Access Compliance Report

Public Rights-of-Way

(Curb Ramps)

Intersection ID: 16419	Main Street: LANTANA_AV	Cross Street: N_SHARON_AMITY_RD	Location: SE
ADA ID: 46A4E83550BD	Ramp Type: ParaDiag	Initial Pass/Fail: Fail	Overall Compliance: No
Severity Score: 12.5			
Codes/Mitigation Info/Possible Solution		Field Measurements/Component Compliance

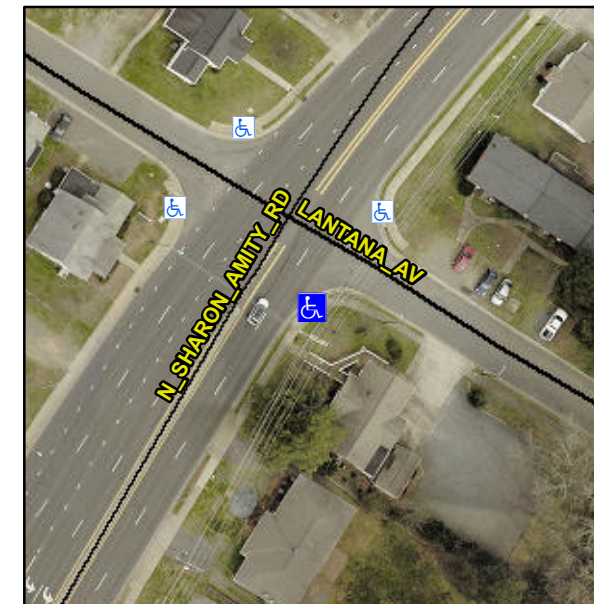
LT RP < 5%

PROW/ADA:

R304.3.2

Remove & Replace Curb Ramp With Two New Directional Ramps or Equivalent.
